**PWYLLGOR CYNLLUNIO - DYDD IAU, 30AIN MAWRTH, 2023**

**ATODIAD  
ADDENDUM**

**Report of the Head of Place  
and Sustainability  
Place and Infrastructure**

<b>Application No</b>	<b>PL/05039</b>
<b>Proposal</b>	Provision of traveller site with twin unit caravan, day/utility room, touring caravan, agricultural buildings, solar array and access improvements (partly in retrospect)
<b>Location</b>	Bryngwyne Fach Farm, Carmel, Llanelli, SA14 7UH

Designed by	Checked by	File name	Date	Scale	Client
		AVH_934	13.03.2023	A3 @ 1:500	Gina De Wolf & Johan Van Mansart & Family
Drawing Title					Dwg No.
Site Plan					<b>02d</b>

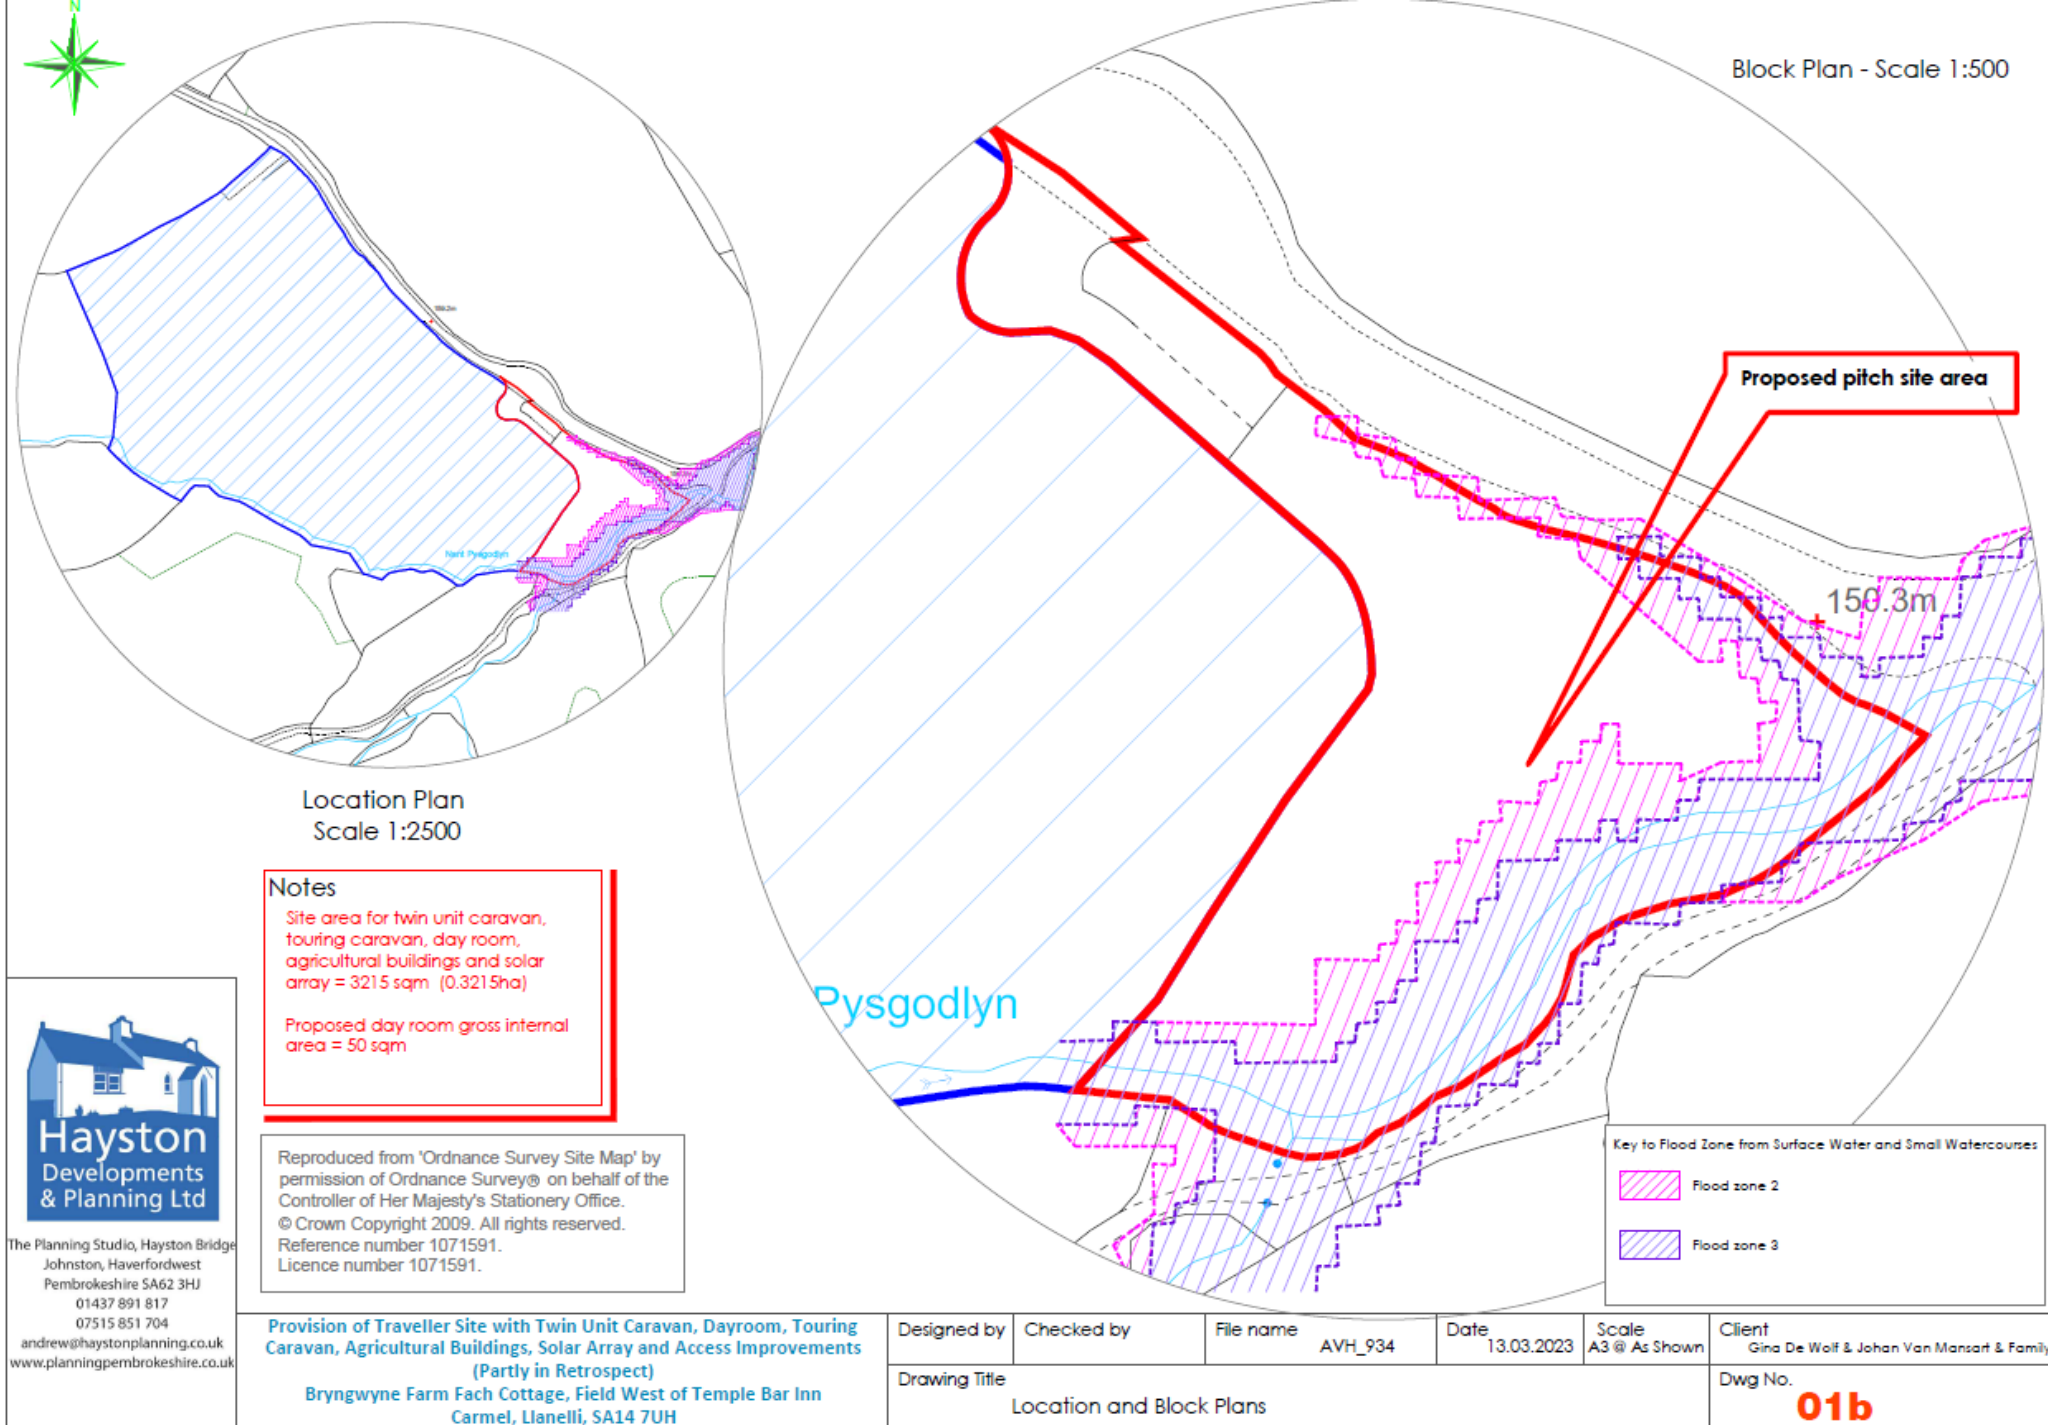
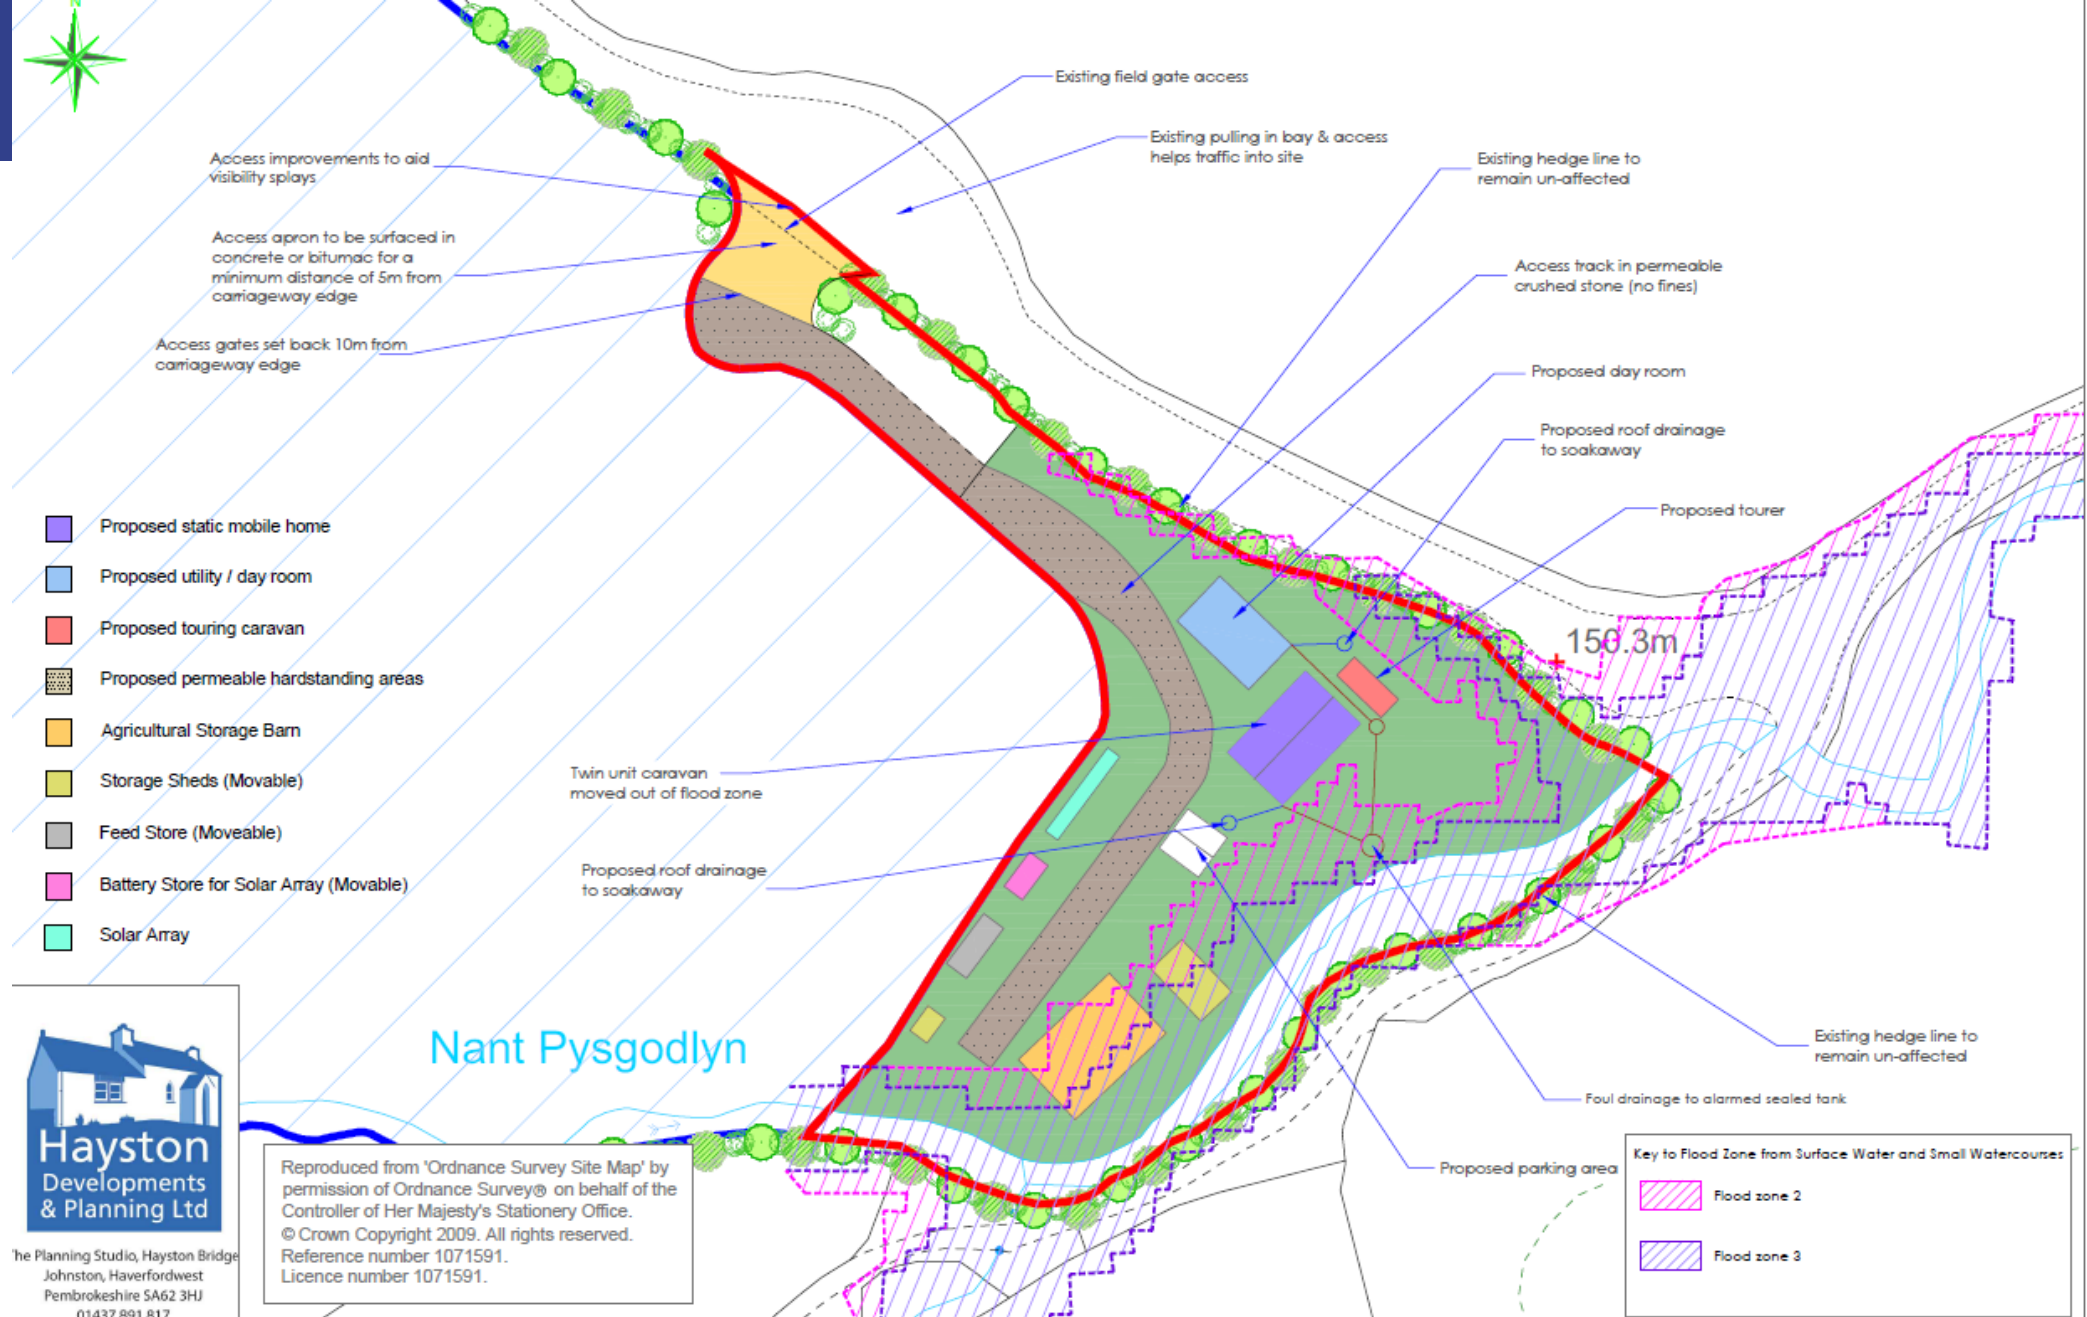
The re-siting of the residential elements of the proposal to areas within the application site area not affected by the flood zones is welcomed and as such remove highly vulnerable development from the flood zone areas. Nevertheless, the remaining residential amenity area along with the agricultural and storage buildings will remain within the flood zone areas. The Council's Sustainable Drainage Approval Body (SAB) have reviewed the application as amended and have since confirmed that despite the residential elements being moved from the affected flood zone areas, there remains to be concern over the continued presence of the agricultural barn and storage shed within the flood zone. To this end, the SAB team continue to advise that a plan should be provided to ensure that adequate measures to protect the development from flood risk are included and that evidence, in the form of a flood consequence assessment, that the development and any mitigation measures would not adversely affect downstream or neighbouring properties in terms of flood risk is required.

Therefore whilst reason for refusal 5 has been partly addressed in terms of re-siting of the highly vulnerable uses outside of the flood risk areas, it remains that insufficient information has been provided to demonstrate that the proposal has fully taken flood risk into account and the resultant risks are minimised. It is considered that this information is required at this stage to ensure that any additional works which may or may not be needed can be fully considered and assessed.

The revised proposals now indicate that a bespoke private treatment plant is to be provided rather than the current sealed cesspit arrangement as a means to overcome reason for refusal 4. The revised submission includes the Circular 08/2018 private foul drainage hierarchy of seeking private treatment plants in the first instance, followed by a septic tank and then a cesspit. The revised plans indicate that a package treatment plant is to be installed subject to satisfactory percolation tests. These percolation tests have not been carried out to date, and therefore there remains a case of insufficient information to demonstrate that the now proposed private treatment plant is capable of being implemented. However, it is recognised that the applicant is now willing to entertain an improved foul drainage arrangement and as such, on balance it is considered that conditions could be imposed, in the event that planning permission were to be granted, to ensure that sufficient information is provided to demonstrate that a private treatment plant could be implemented. Such a condition however would have to be carefully constructed given the retrospective nature of the development and would require submission of the required percolation tests within a specified time frame from the date of the decision, and should they be favourable to provide full details of the treatment plant and its subsequent installation and commissioning along with decommissioning of the existing tank all within a reasonable time period. However such a condition could be imposed and therefore it is considered on balance, that reason for refusal 4 could be removed.

In conclusion therefore, whilst the matters that have been raised by the agent are acknowledged, with the exception of reason for refusal 4, it is not considered that the above overcomes any of the other reasons set out in the original report and as such the application remains to be recommended for refusal on the grounds set out in the original report with the exception of reason for refusal 4.
